Northwestern Water and Sewer District  
2024 Portage Water Main Replacement  
WL-306E

**ADDENDUM 1**

8/8/24

JOB NO. 796-8122.001  
SCALE AS INDICATED  
THIS LINE SCALES IF WHEN PLOTTED TO NOTED SCALE  
DESIGNED EAF DRAWN DJK CHECKED TAB  
STATUS ISSUED FOR BID  
DATE MAY 2024  
SHEET NO. G-0.3  
3 OF 25

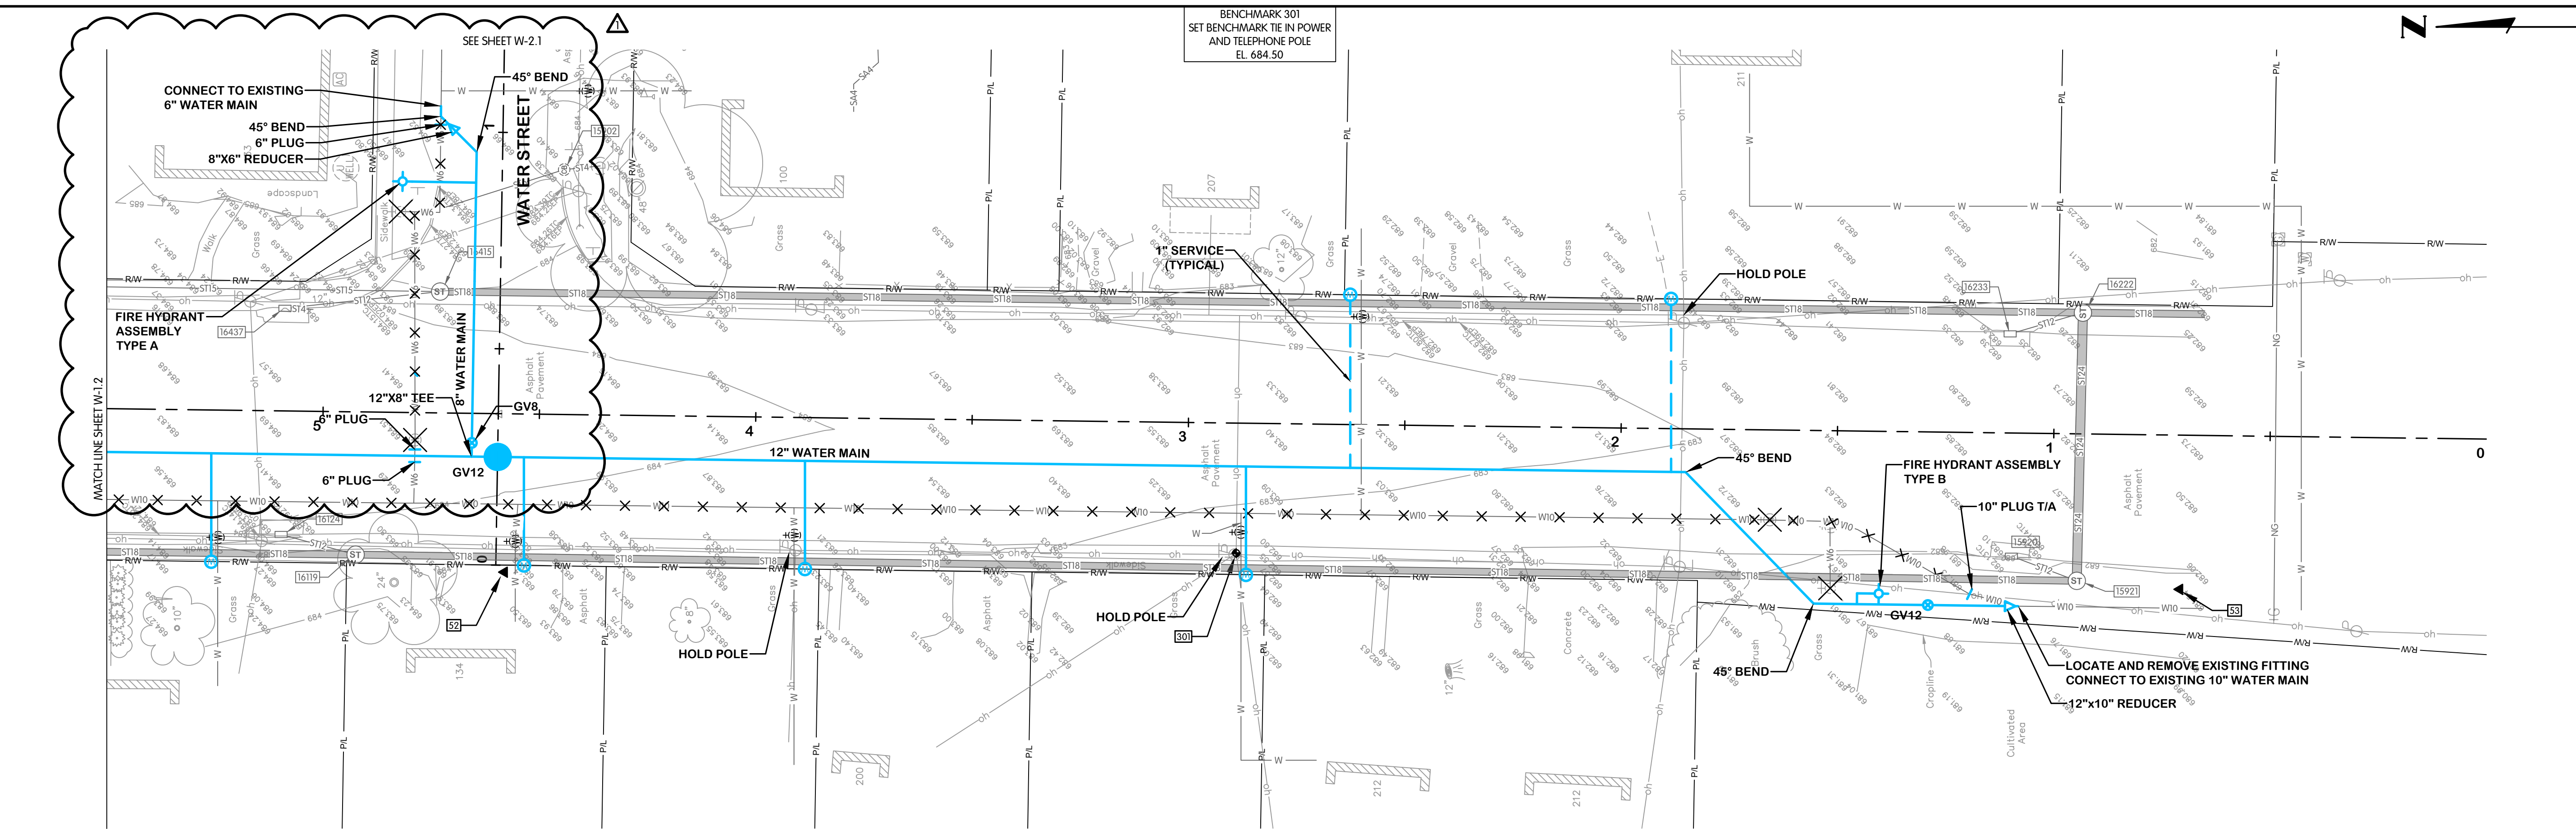
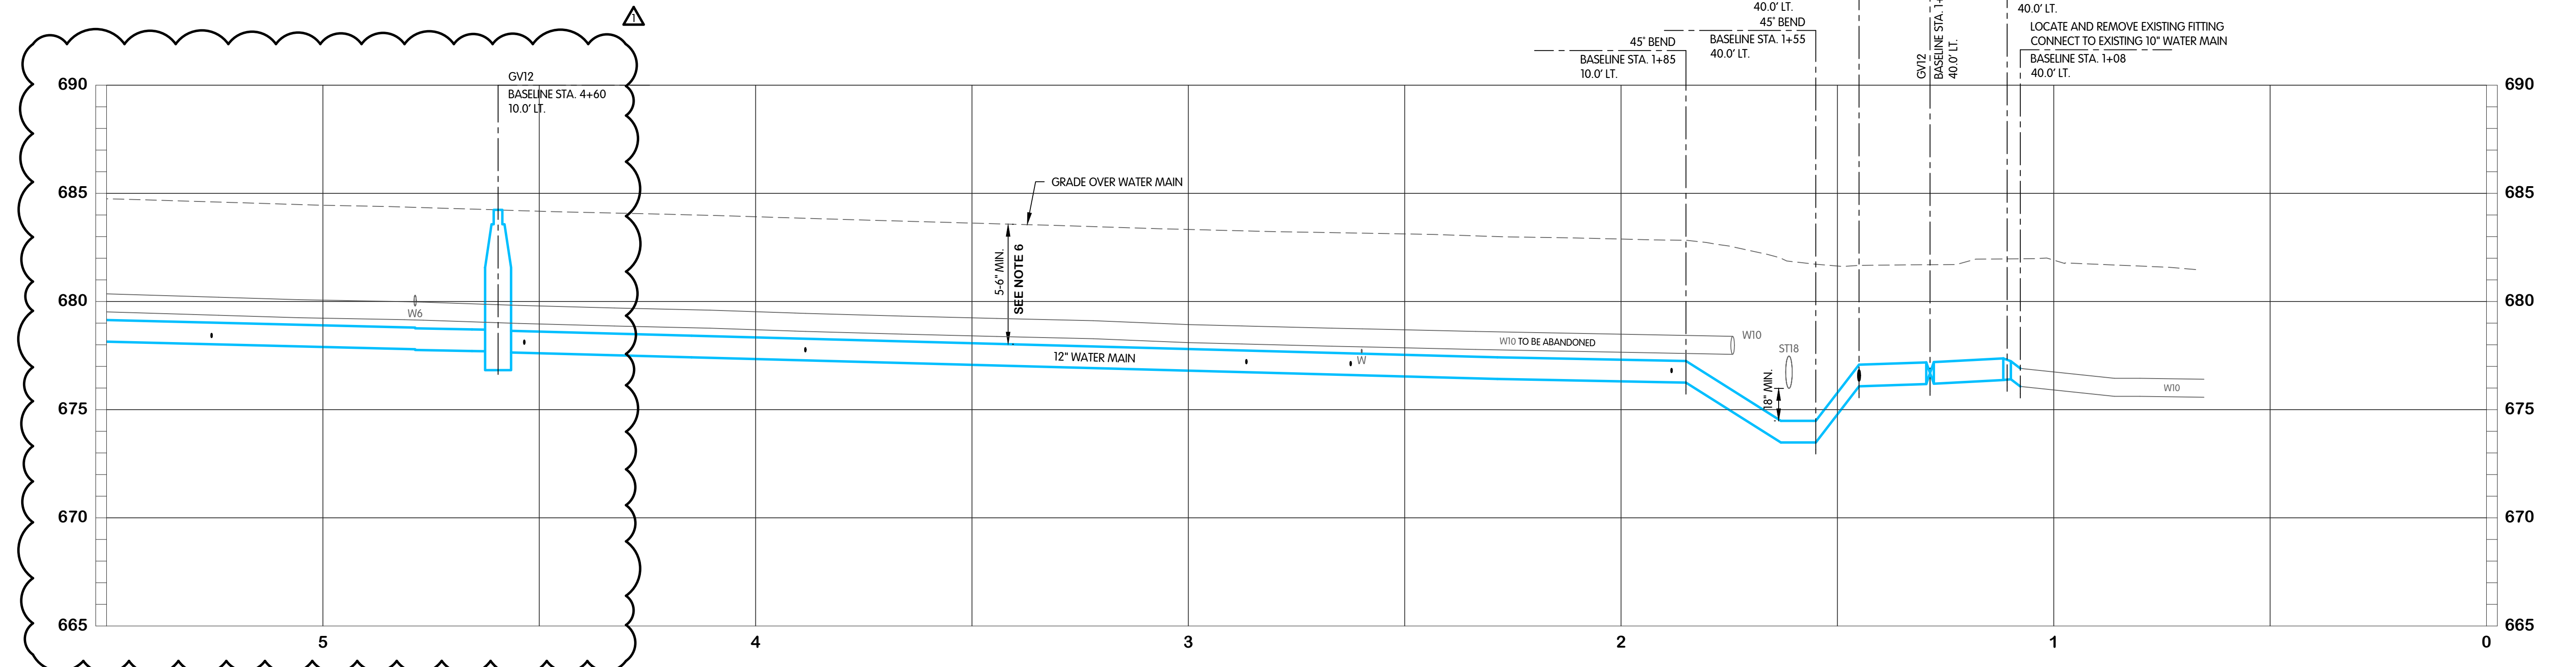
Replace Sheet G-0.3 with the attached sheet that shows the updated items and quantities.

SHEET NO. W-1.1  
4 OF 25

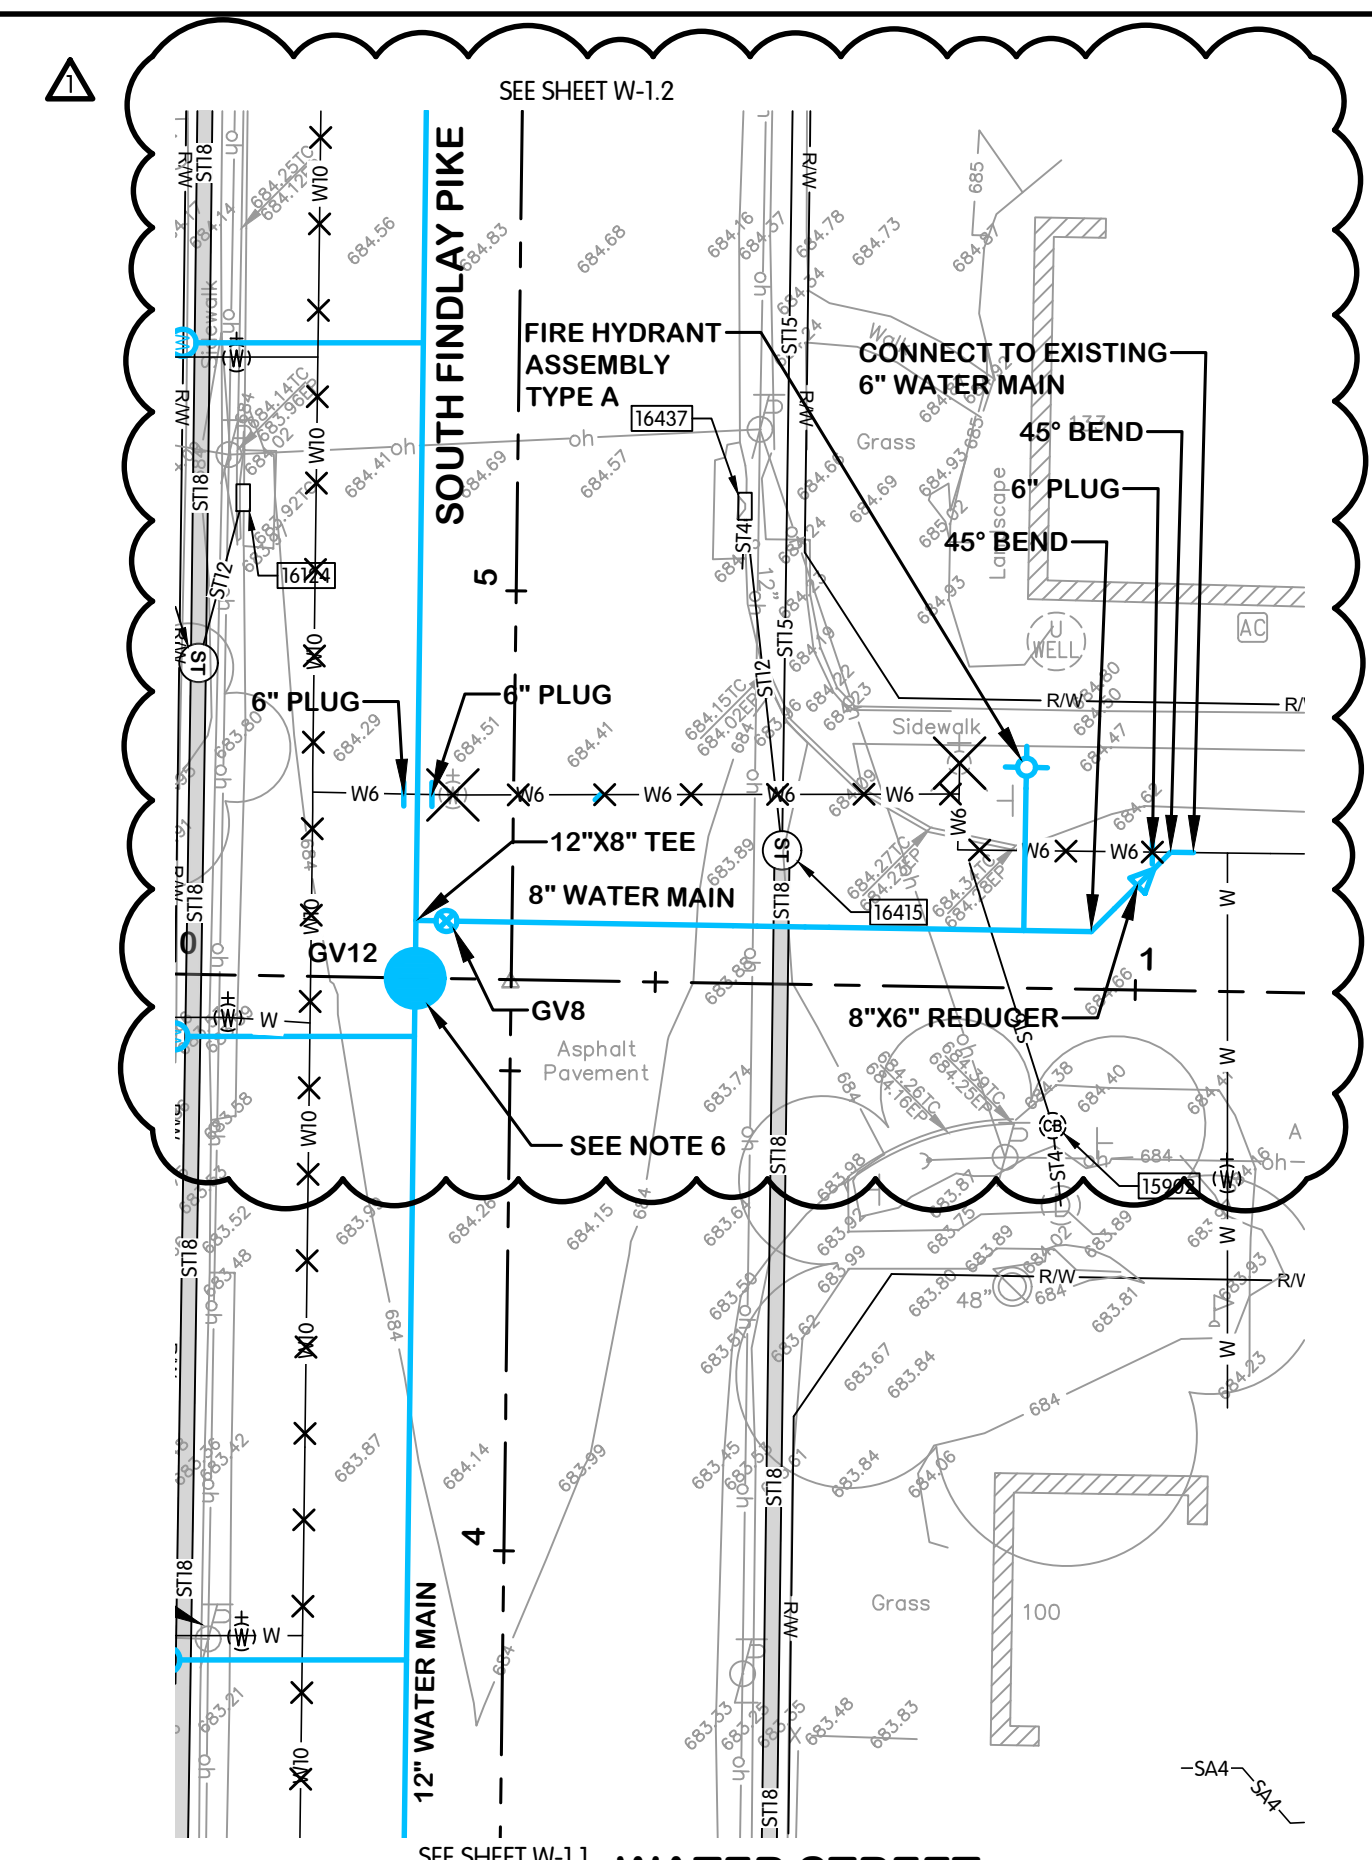
Replace Sheet W-1.1 with the attached sheet that shows the updated connection at Water Street.

JOB NO. 796-8122.001  
 SCALE 1"=20' HOR.  
 1"=4' VERT.  
 THIS LINE SCALES IF WHEN PLOTTED TO NOTED SCALE  
 DESIGNED EAF DRAWN DJK CHECKED TAB  
 STATUS ISSUED FOR BID  
 DATE MAY 2024  
 SHEET NO. W-2.1  
 9 OF 25

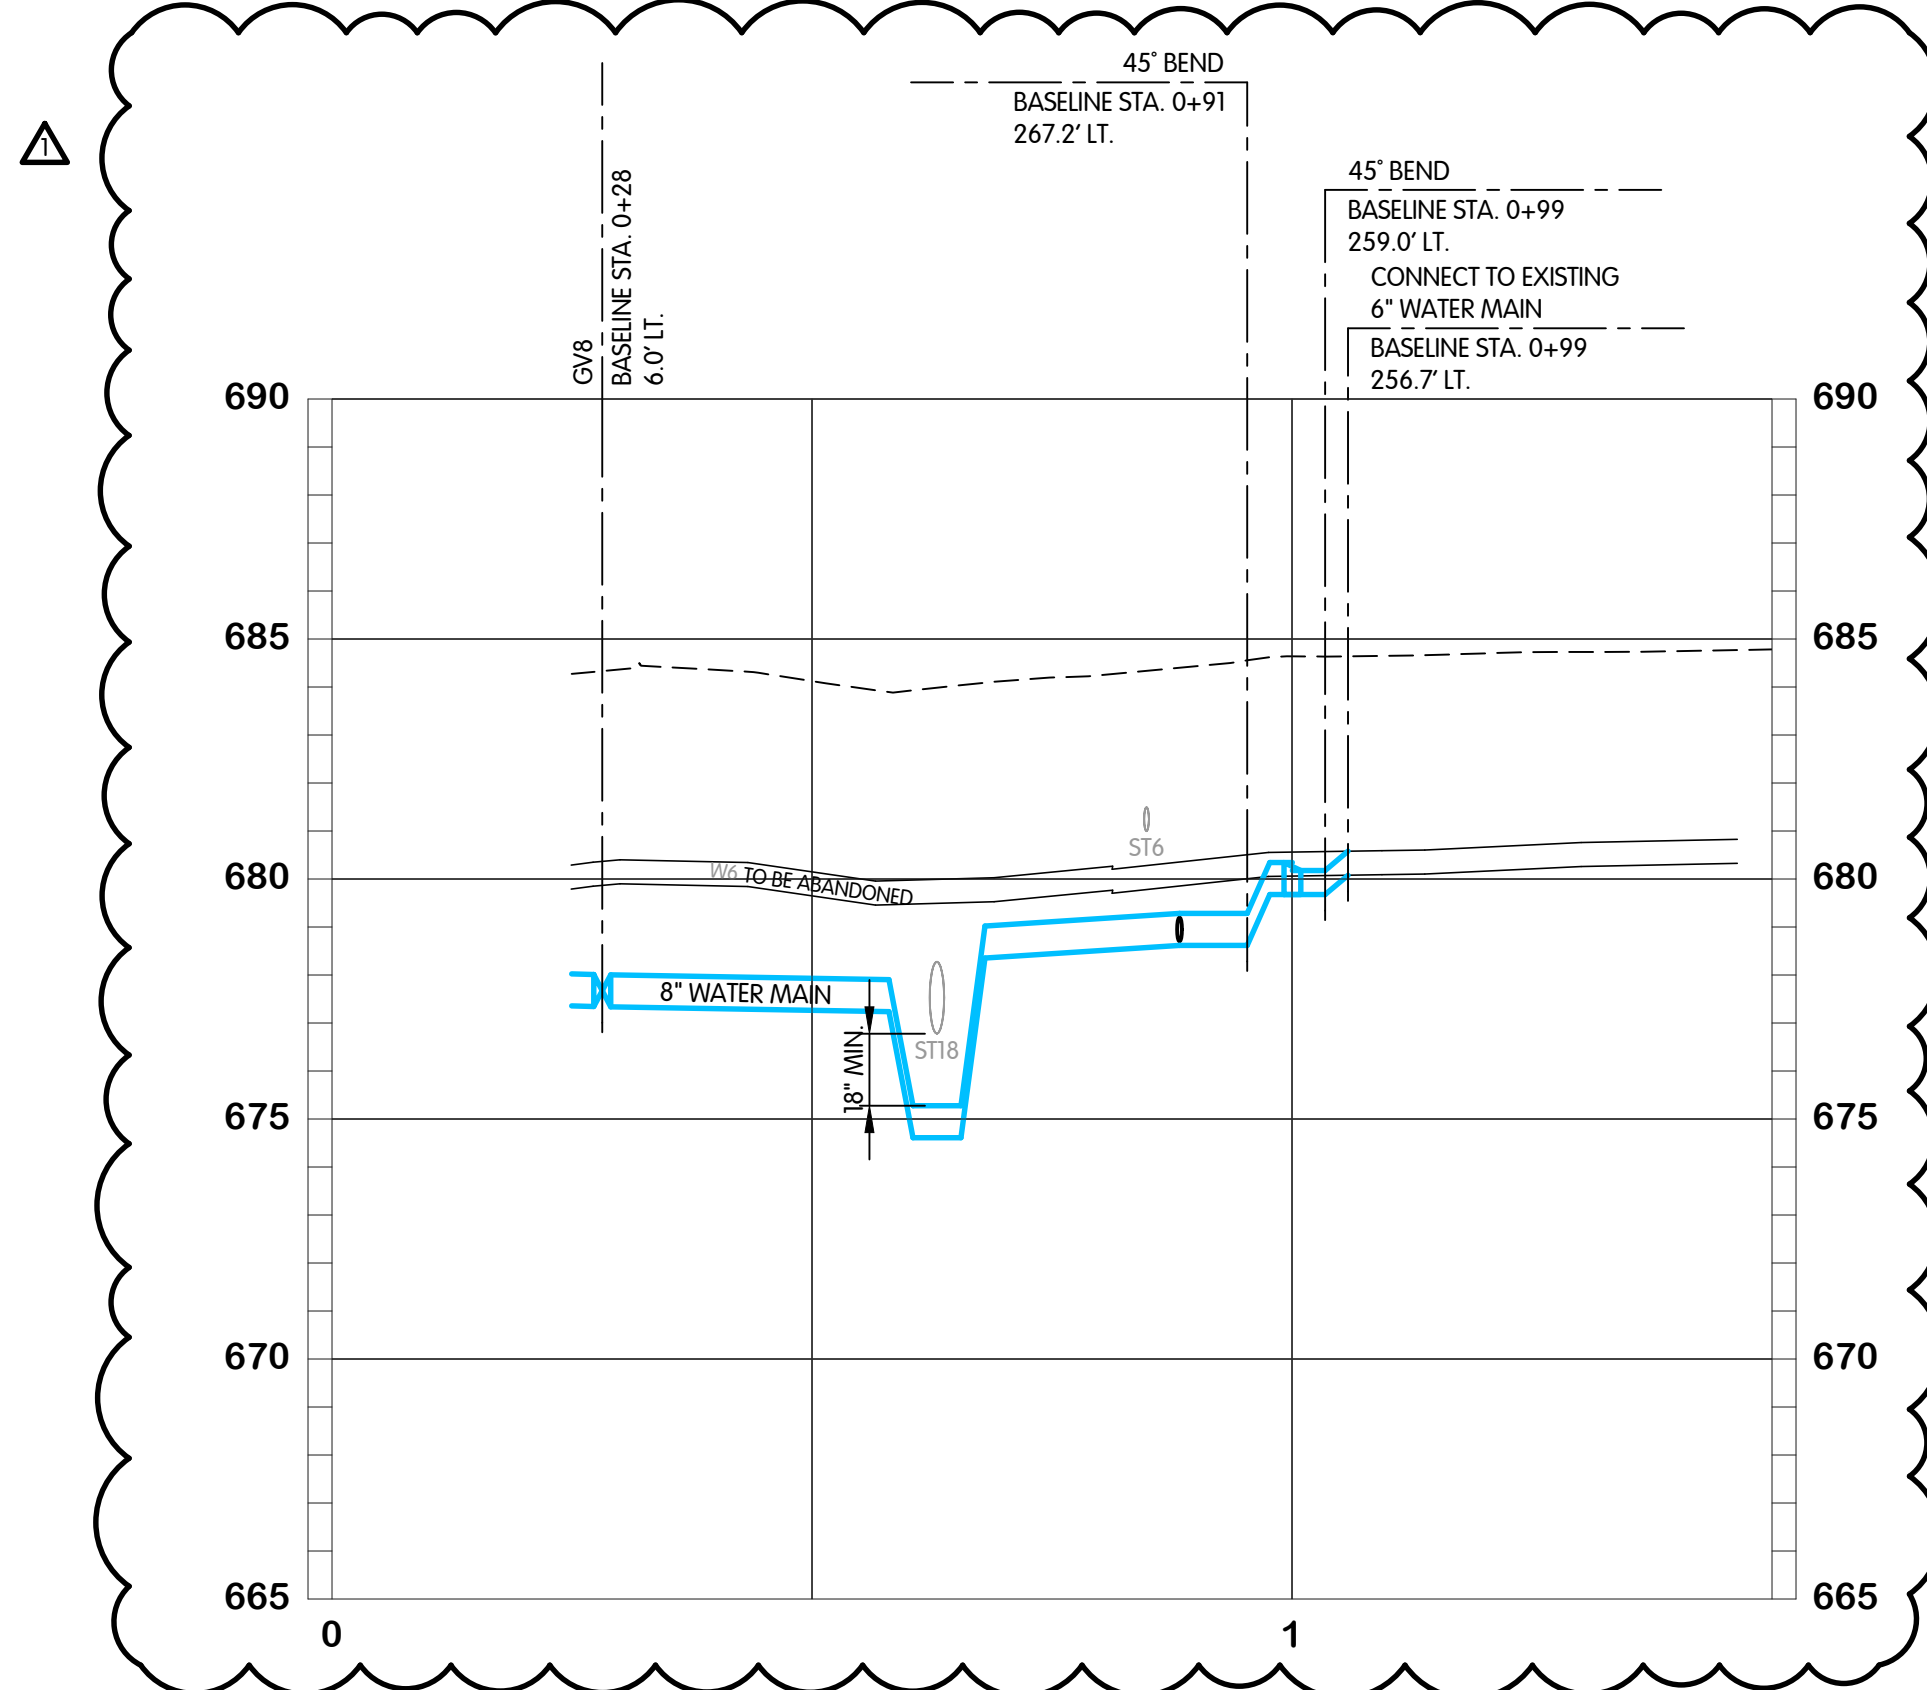
Replace Sheet W-2.1 with the attached sheet that shows the updated connection at Water Street.
